Planning Commission Meeting Date: April 7, 2016

PLANNING COMMISSION AGENDA ITEM
CITY OF SHORELINE, WASHINGTON

AGENDA TITLE: Public Hearing on Zoning Alternatives and Recommendation to Council on Preferred Zoning Alternative for Final Environmental Impact Statement

Figure 5: Twin Ponds and Paramount Park Wetlands and Streams

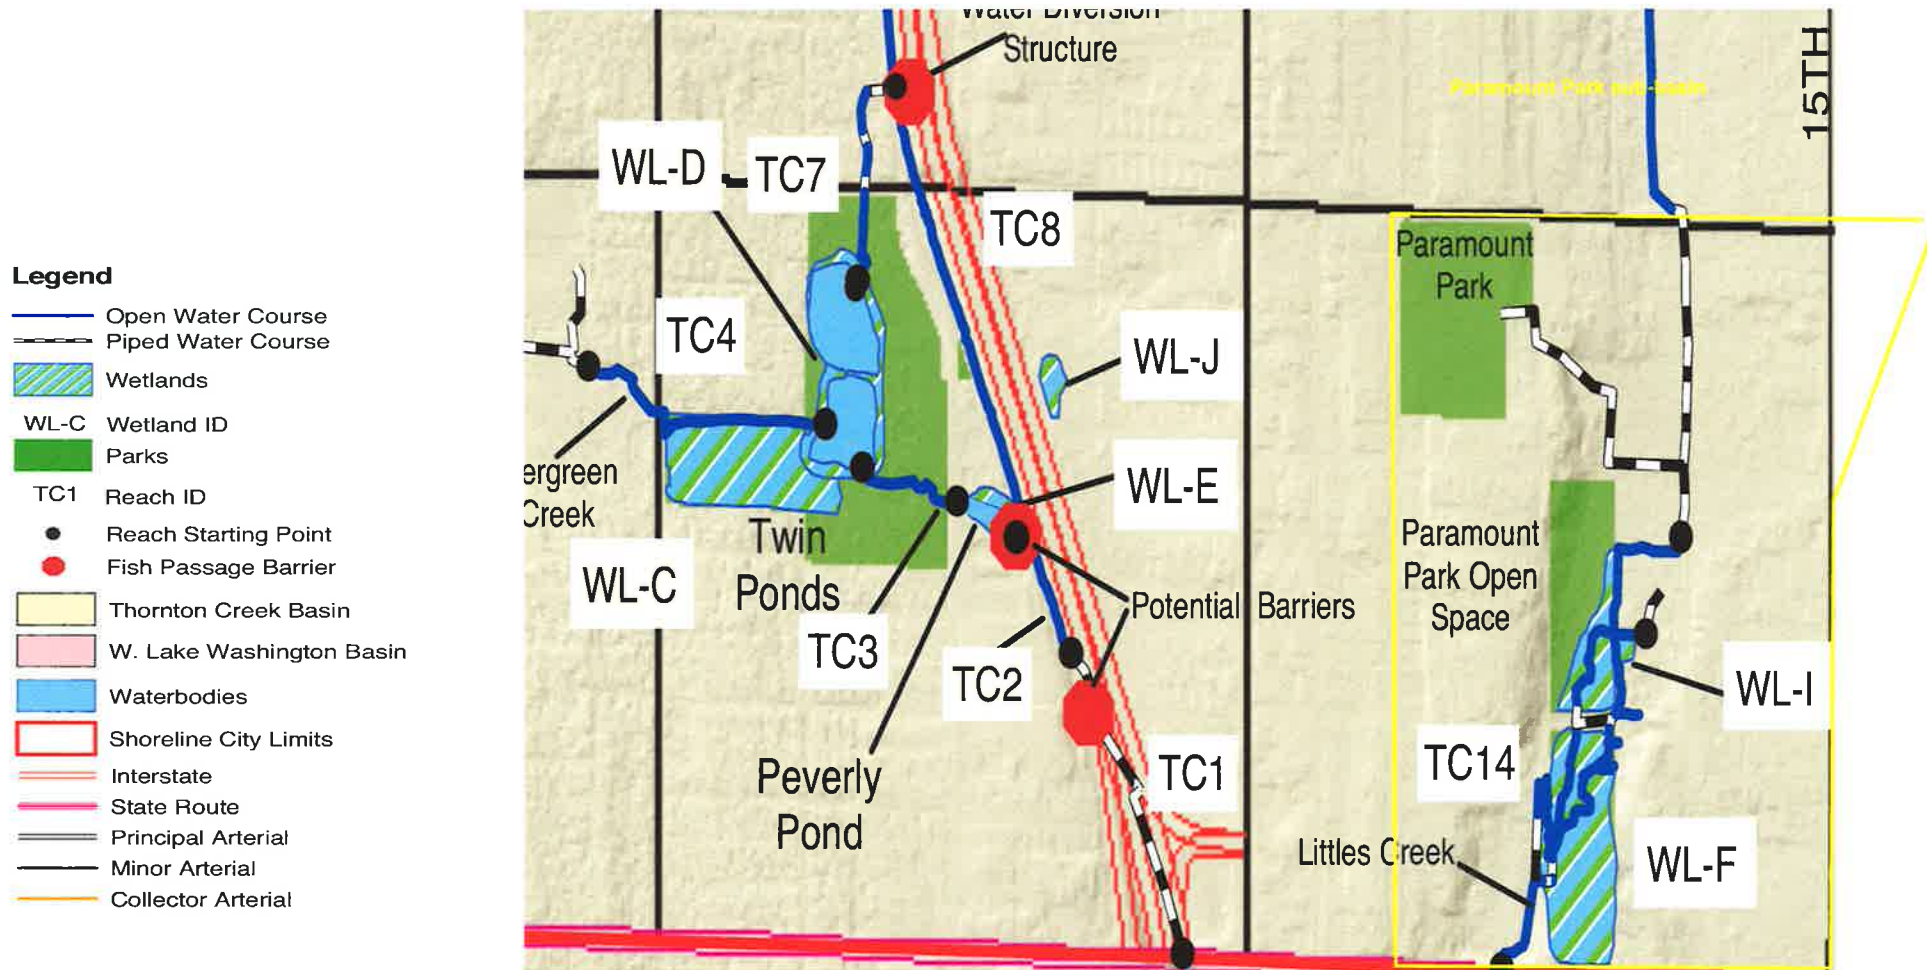
The two ponds and associated Wetland WL-F on Figure 5 were enhanced and/or constructed by local volunteers under a Water Quality Block Grant awarded by King county Department of Natural Resources prior to the 2004 basin characterization report. These areas are now well established and the plantings installed back in the early 2000's are now well established. Photos on photo sheet 6 of the attached photos show some examples of this area.

Creek, flows through Wetland WL-1 (2004 inventory, Figure 5) and a drainage tract with landscaping; and the eastern arm flows through on the edge of Wetland WL-L and through Wetland WL-F (also Figure 5 where it enters the pond and wetland enhancement area identified above supplying the wetlands, seeps back into the second pond via small channels described above and then flows west into the main channel of Littles Creek. The stream through the Park is generally still in good condition with sufficient bank vegetation and sparse armoring and fair pool frequency. Gravel and quarry spall is present in the south end of the reach but overall this segment is the ONLY one of the three segments of Thornton Creek within the City of Shoreline that was given a "fair" rating when assessed (Tetra Tech 2005). It is imperative that the City do all it can to maintain the integrity of these tributaries should the new zoning become reality. Increasing residence density on the east side of the Park would be in the direct path of many of these channels and no additional piping should be allowed. It should be noted that the DEIS states that Littles Creek lies ½ mile from the Proposed Light Rail Station, but actually it is only ¼ of a mile.

Figure 6: Paramount Park Wetlands and Streams Mapping. City of Shoreline GIS 2016.

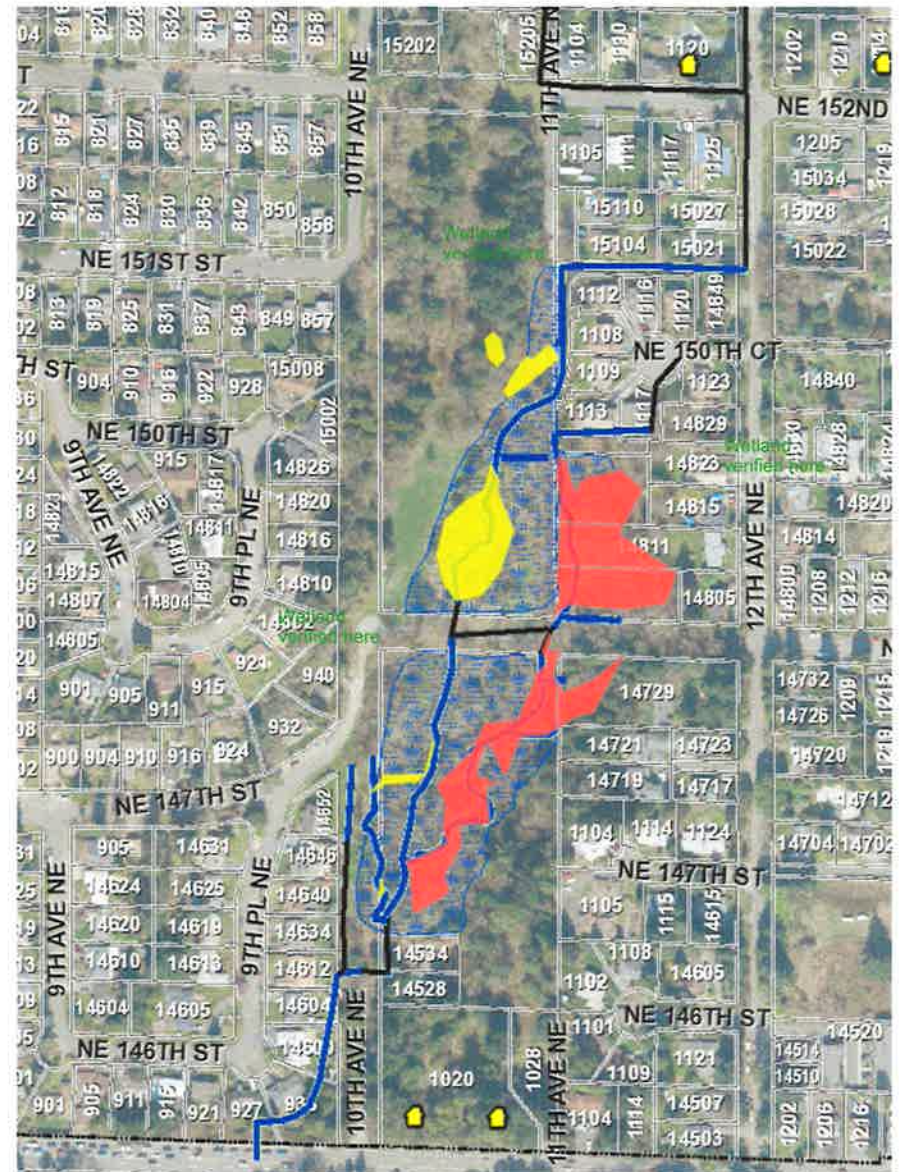
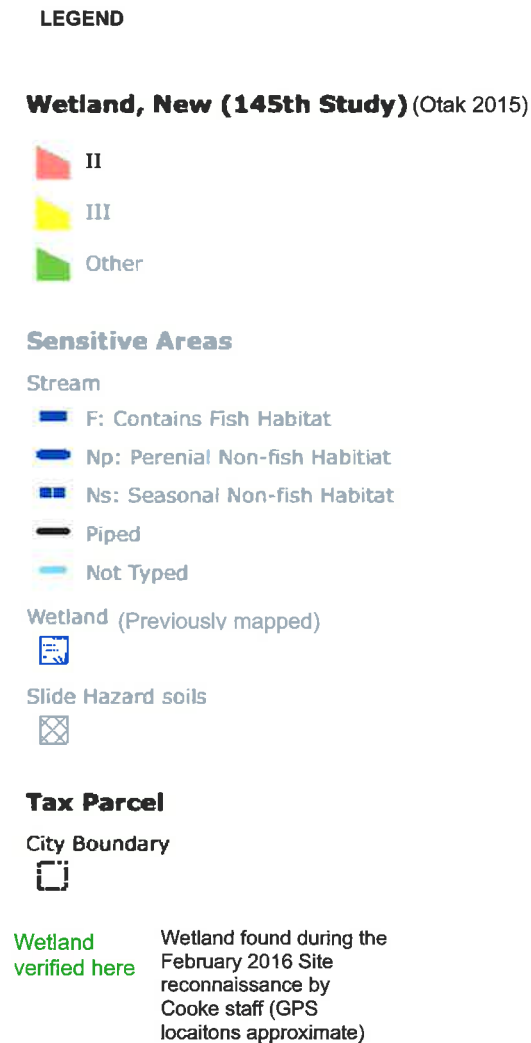
part of the park, (Figure 6 arrows showing where additional wetland was found; Figure 8 photo map and Photos 21-25). We also found more wetland in the northeast corner of the Park and associated residences that are not shown on the Otak map (Figure 6 arrows showing where additional wetland was found; Figure 8 photo map and Photos 1-10). And more wetland in the central part of the park between Wetland F and Wetland C such that these two wetlands are actually one wetland system (Photos P1, P2, P18, and P19). Additionally, many of the residences on the east side of the Park along 12th Avenue NE had wetland continuing into their western back yards abutting the Park (Figure 6 arrows showing where additional wetland was found; Figure 8 photo map and Photos 12-20). Much of this area was also not included as wetlands mapped by Otak. Approximate GPS locations of wetlands found during our February reconnaissance are shown on Figure 8 where the photo pins are located and on Figure 6 where the arrow points indicate locations where both photos and GPS points were taken in areas that were wetlands.. The arrows shown on Map 6 do not show a formal delineation map. It is indicating areas that met wetland criteria and which were not identified on the Otak map as being wetland. A word about the photos included: The photos show characteristics about the ground conditions – either the vegetation prevalent (which is usually wetland species for the wetland shots) or the soils conditions (again showing wetland soils), or standing water indicating the area has wetland hydrology. When the shots are of upland they indicate this.

The Otak reconnaissance wetland map is also displayed as a layer on the City's Wetland map as a layer that is shown as either a blue or yellow polygon/series of polygons on Figure 6. as the with Wetland III having a much reduced footprint of wetland WL-I and the red pattern with a much reduced footprint over the previous delineation also shown as the blue shaded pattern on Figure 6.

The drainages (streams and creeks) mapped in the Park by Otak (Figures 6 and 7) include some omissions that have been added back as the black lines on the City's GIS database (Figure 6). We observed these creeks/drainages are still present when we performed our reconnaissance on January 29th, 2016 (Photos P8, P9, P11, P17, P20, P23, P24, P21, and P25). Little's Creek is the main tributary to Thornton Creek through the park but there are many other tributaries, wetlands, ponds and connecting channels that are also present (See Figures 5 and 6). Some of the channels are now piped, especially the main channel that passes through a culvert under the gravel road the bisects the Park from north to south (photo P17).

Figure AW-1
Critical Areas - Paramount Park
Critical Areas Memorandum
Draft Environmental Impact Statement
145th Street Station Subarea Plan
City of Shoreline, WA

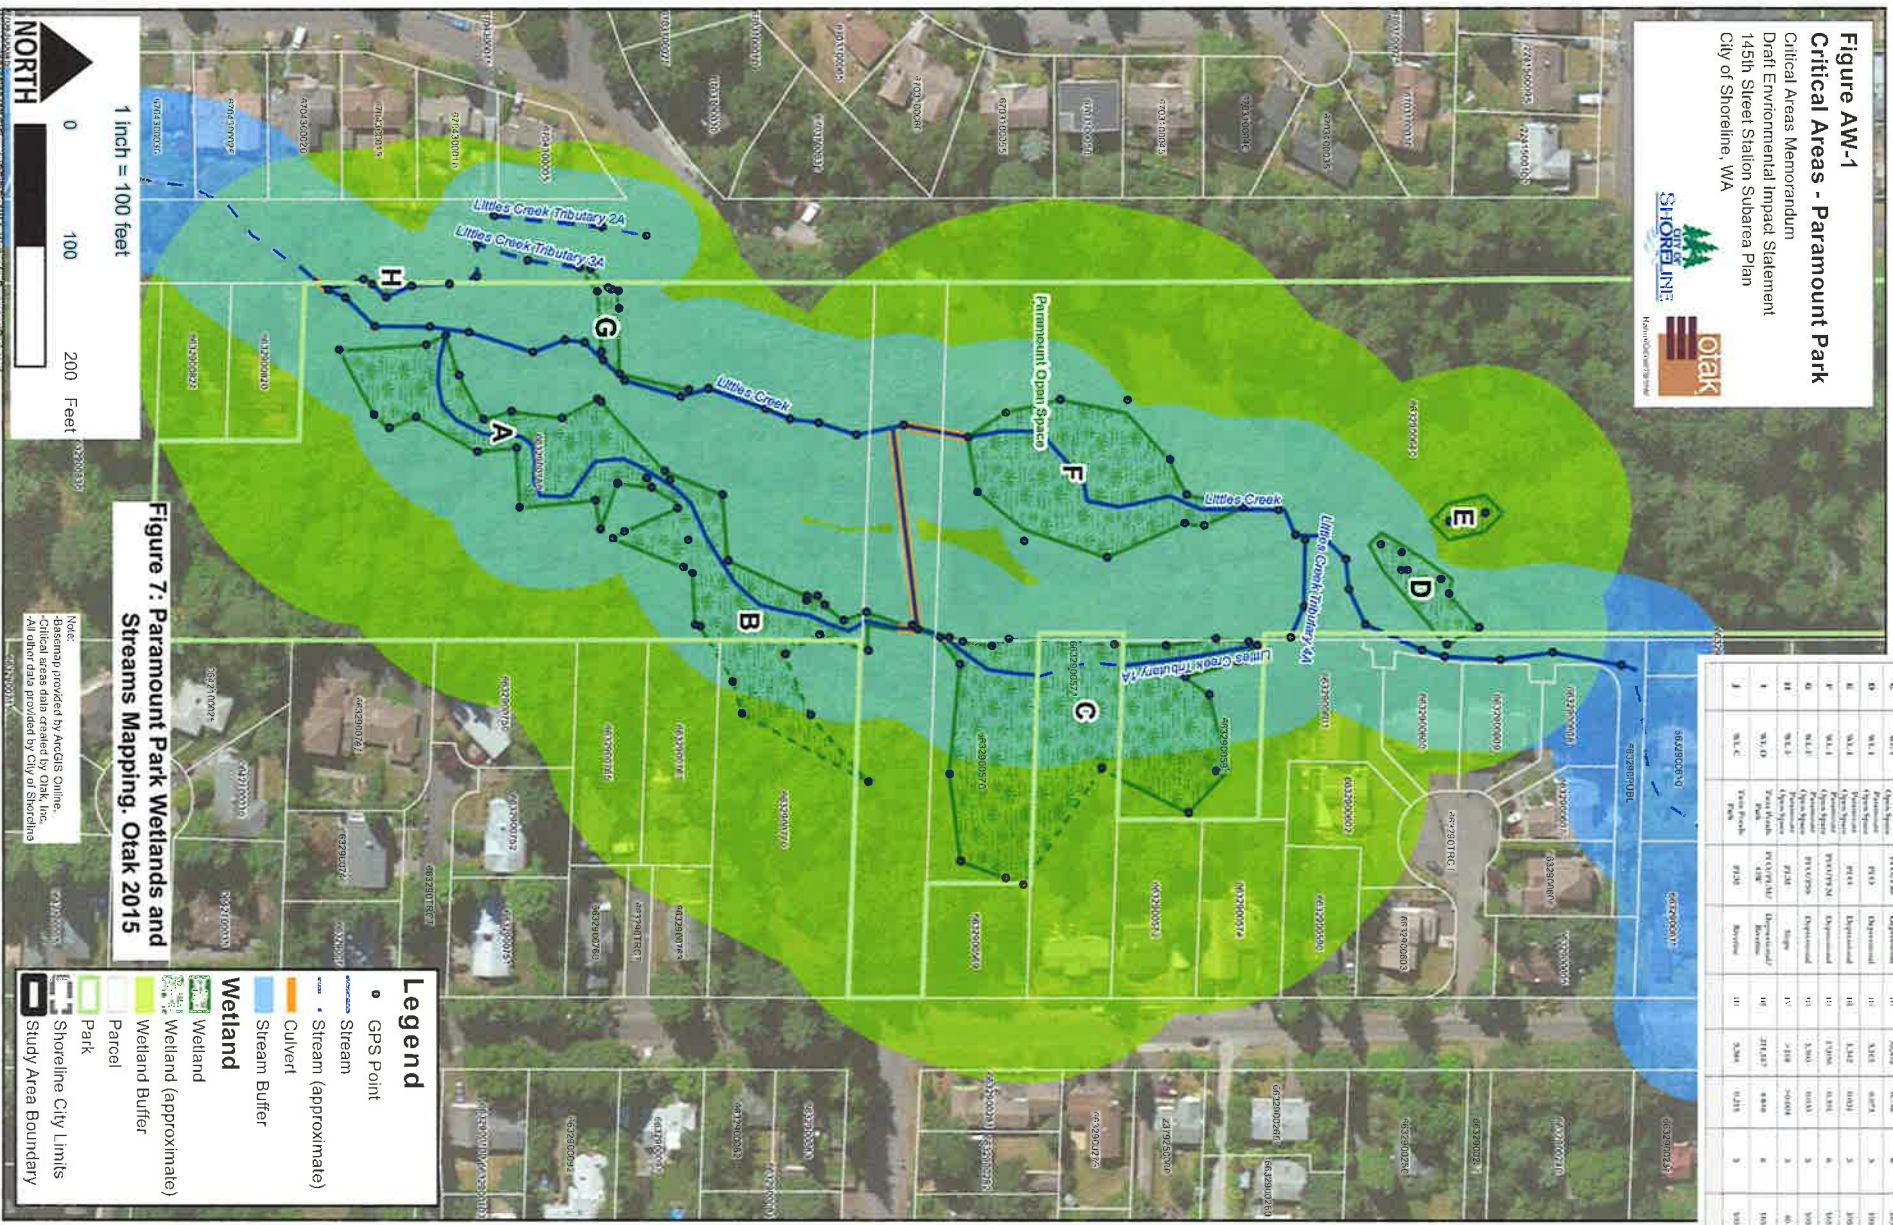
We would also note that Figure AW-1 in OTAK's report, "Critical Areas – Paramount Park," does not, in fact, seem to substantiate the report's claim that there are currently structures actually located in the wetlands that extend out from the park. Certainly no houses appear to be in the wetlands. There are six houses along 12th Avenue Northeast that are within wetland buffers, but in five of these cases all or essentially all of the parcel is inside the buffer and in the other case far too little of the parcel is outside the buffer to be developable. This means that reasonable use requirements would almost certainly still
